Re: Revised Interim Remedial Measure Work Plan, 920 Exchange Street, Rochester, New York, BCP Number C828218

**RESPONSE TO NEW YORK STATE DEPARTMENT OF ENVIRONMENTAL
CONSERVATION, REGION 8
COMMENTS DATED JUNE 3, 2024
ON THE INTERIM REMEDIAL MEASURE WORK PLAN
920 EXCHANGE STREET, ROCHESTER, NEW YORK
BCP SITE NO. C828218**

Interim Remedial Measure Work Plan 920 Exchange Street, Rochester, New York Revision 1

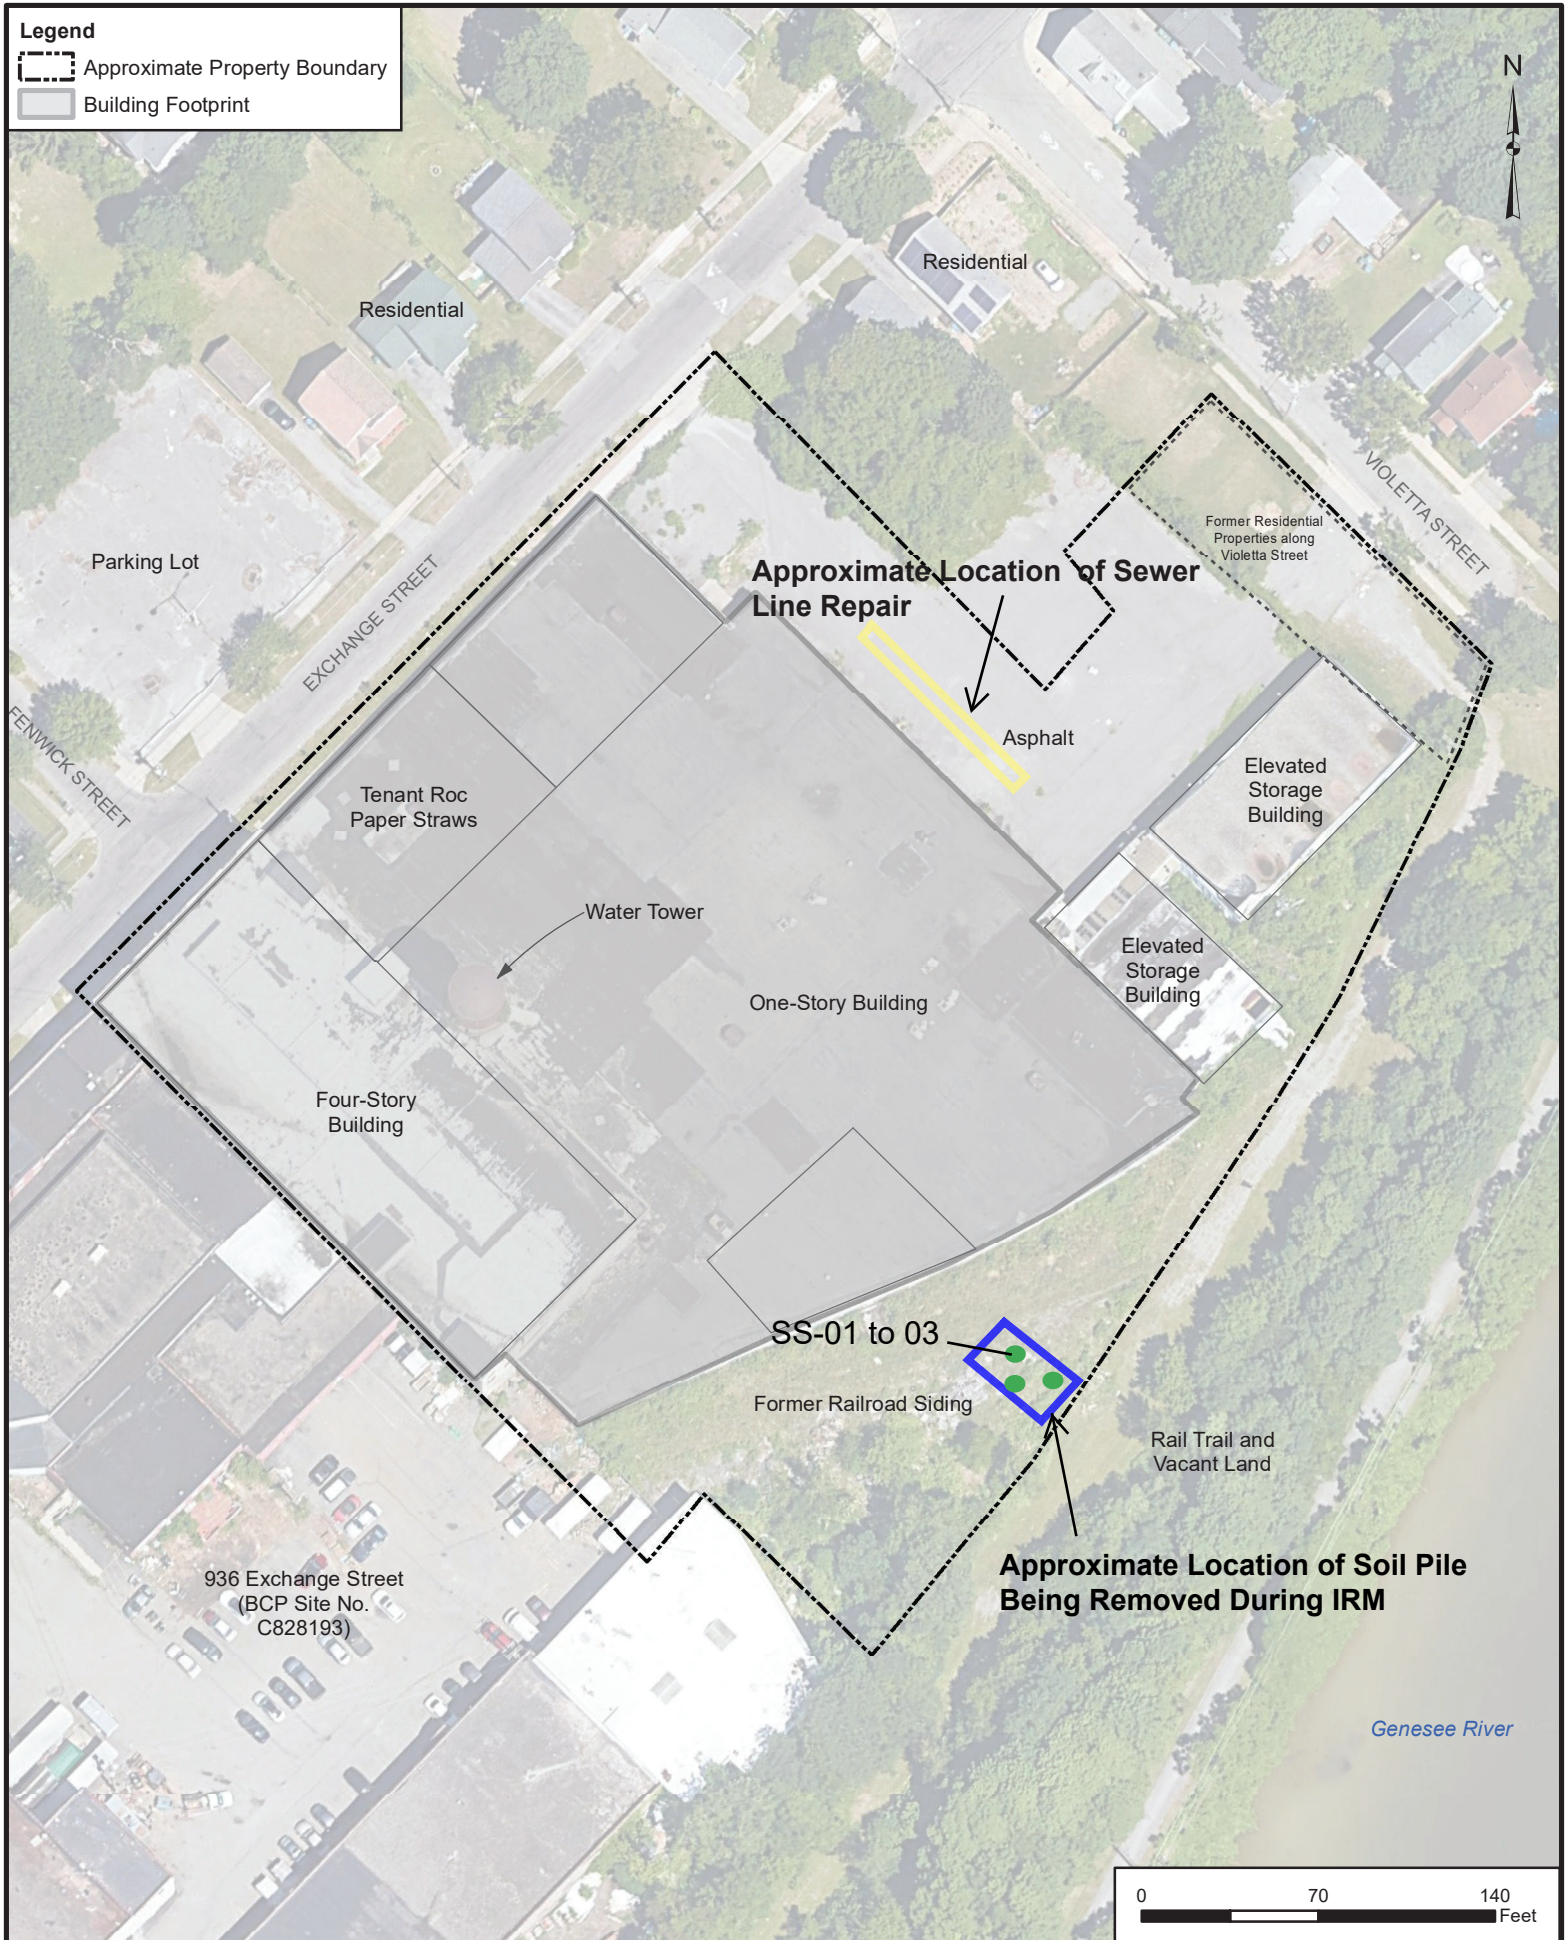
Comment No. 5: Section 2.1 – Soil Pile Removal – Restricted residential soil cleanup objectives require two feet of clean cover. If six inches of soil below the pile are removed, and the following twelve inches are tested, that leaves a gap of information with respect to the 18–24-inch interval. This area must be evaluated separately from the remaining green space areas.

The proposed sampling is not consistent with DER-10 section 5.4(b)5 (confirmation sampling sample frequencies). DER-10 section 5.4(b)5 requires one grab sample per excavation side wall per every 30 linear feet.

As the soil pile has been sitting since 2021, the potential for leaching into the subsurface exists and must be evaluated. As a result, the Departments are requiring additional sampling from what is required:

- a. The Departments are requiring the sampling plan to be revised as follows:
 - i. Sidewalls
 1. One grab sample per every 30 linear feet per excavation side wall must be collected and analyzed for VOCs, SVOCs, and metals.

Response: As noted in earlier response to comments, the Work Plan has revised to eliminate text specifying the removal of the soil six inches below the soil pile. Therefore, eliminating post-excavation requirements (see amended language above). The revised sampling protocol includes collection of three soil samples from 0 to 6 inches below the bottom of the soil pile that will be analyzed for VOC by EPA Method 8260 and SVOC by EPA Method 8270 to assess whether downward migration of petroleum may have while the soil pile was staged. Results of the three grab samples from below the soil pile will be reviewed and if concentrations of petroleum is noted the need for any additional samples assessed as part of the Remedial Investigation to identify any potential data gaps in conjunction with the remedial approach for this area.

Three grab samples for VOC and SVOC analysis will be collected from different locations within the former footprint of the soil pile from the 06 to 612-inch bgs interval for a total of 3 samples for VOC analysis. These samples will be used to assess whether petroleum compounds may have migrated from the soil pile into underlying soil. Results of the three grab samples from below the soil pile will be reviewed and if concentrations of petroleum is noted the need for any additional samples assessed as part of the Remedial Investigation to identify any potential data gaps in conjunction with the remedial approach for this area.

After the soil pile is removed, confirmatory and/or documentary surface soil samples (Soil Pile-01 to 03) will be collected from below where the pile was located to confirm the petroleum impacted soil was fully removed.

Figure 3 shows the approximate locations where the soil samples will be collected. Specific locations will be identified in the field based on field conditions and in consultation with NYS DEC staff.
